# **HOLDOVER**

## **GRACELAND COURT SUBDIVISION**

APPLICATION NUMBER Holdover DATE June 16, 2005

# DETAIL SITE PLAN

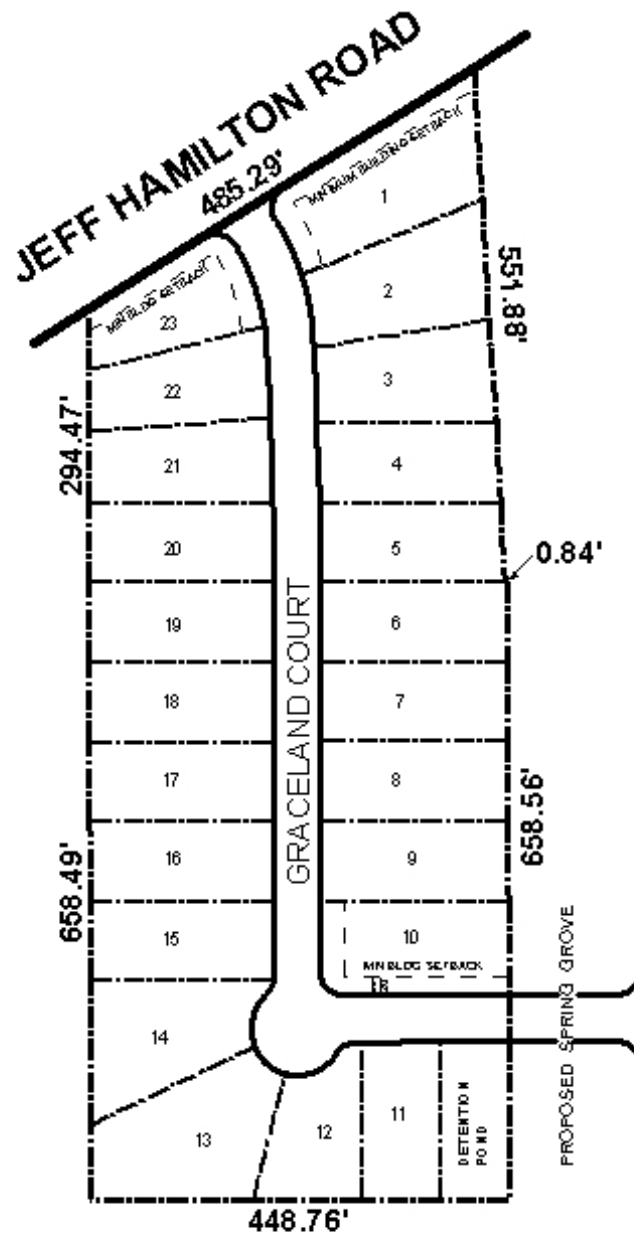
The site fronts Jeff Hamilton Road, which has a right-of-way of 80 feet. As the subdivision involves the creation of a new street, construction and dedication will be required. As proposed, the new street would be closed-ended and exceed 600' in length. However, there is a large parcel to the east that has received subdivision approval (Spring Grove, Unit Two) with a street stub extending west to the site; thus a street stub to the east connecting to the Spring Grove street stub should be required, and would resolve the issue of the closed-end street.

The plat also illustrates a detention pond in the southeast corner, which would conflict with the street stub connecting to Spring Grove; furthermore, no access easement is shown to the detention pond. The detention pond should be moved to eliminate this conflict, and if the detention pond does not have frontage on the new street, an access easement should be provided. A note should also be required on the final plat stating that the maintenance of the detention pond shall be the responsibility of the property owners.

As a means of access management, Lots 1 and 23 should be denied access to Jeff Hamilton Road.

*This application was held over from the June 2<sup>nd</sup> meeting at the applicant's request. The applicant has submitted a revised plat illustrating a street stub to the East, connecting to the Spring Grove Street stub; and street frontage for the detention area. These revisions address concerns identified in the previous report. The revised plat does not show the 25' minimum building setback lines for all proposed lots, and would be required for all lots with the following exception: corner lots are illustrated with 20' setbacks (side yard) along Jeff Hamilton Road and along the street stub, which is acceptable.*

*With these revisions, the plat meets the minimum requirements of the Subdivision Regulations and is recommended for Tentative Approval, subject to the following conditions: 1) 1) the construction and dedication of the new street; 2) the depiction of the required 25' building setback lines on the final plat, except for the Jeff Hamilton Road frontage of proposed lots 1 and 23, and the street stub frontage of proposed lot 10, which may have a 20' building setback; 3) the placement of a note on the final plat stating that the maintenance of the detention pond shall be the responsibility of the property owners; 4) the placement of a note on the final plat stating that Lots 1 and 23 are denied access to Jeff Hamilton Road; and 5) the placement of a note on the final plat stating that any lots that are developed commercially and adjoin residentially developed property must provide a buffer, in compliance with Section V.A.7 of the Subdivision Regulations.*
